# UNITED STATES PATENT AND TRADEMARK OFFICE

10/542,935

<b>Office Action Summary</b>	<b>Application No.</b> 10/542,935	<b>Applicant(s)</b> DAMBRICOURT, GERY BERNARD MARIE CORNIL	
	<b>Examiner</b> ERIK KASHNIKOW	<b>Art Unit</b> 1794

## **DETAILED ACTION**

Fig. 5

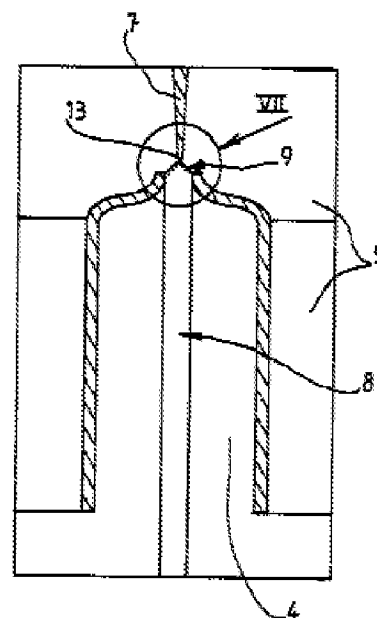
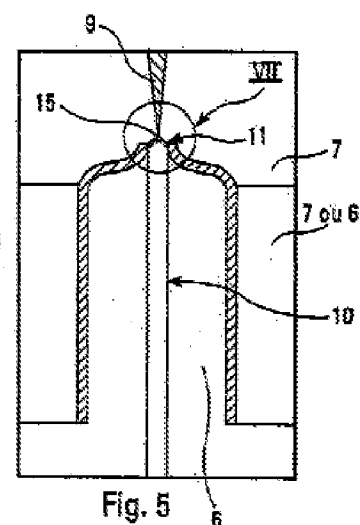
In regards to the requirement that the impression bears a resemblance to the tube skirt, while Dambricourt is silent regarding this the pictures shown by Dambricourt show the same features as the pictures shown by Applicant (Fig 5 Dambricourt (top) Fig 5 applicant (bottom)).

21. In regards to claim 61 and 66 Examiner is treating it as a product by process, for information on product by process see MPEP 2113. In regards to claims 61 and 66 Dambricourt 01 teaches a nozzle (a cavity through which the material is led into or out of the tube (paragraph 0111)) as is shown in figure 5 above. One of ordinary skill in the art at the time of the invention would recognize the area with the narrowing of the tube within the circle as a nozzle. Dambricourt also teaches that a reducer can be incorporated into the tube (paragraph 0129).

Fig. 7

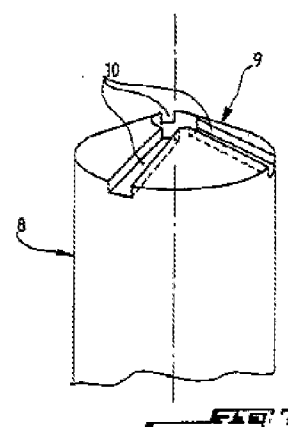
18. In regards to claim 54 Dambricourt 01 teaches using feed channels for the injection molding (paragraph 0122). Dambricourt

01 also shows in the feed or supply channels forming an apex wall (Figure 7).

Fig. 9

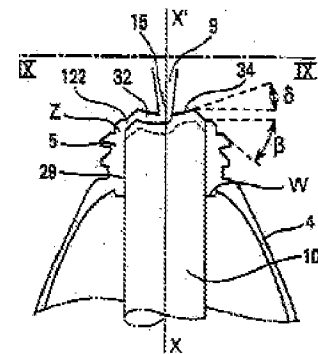
45. While Dambricourt 00 and 01 and Johnson et al. teach the tube and method for forming the tube as shown above, they are silent regarding a ring of material perpendicular to the axial direction under the neck.

47. In regards to claims 67 and 69 Nishikawa shows another conventional embodiment which has the chimney feature described by Applicant (Figure 3).
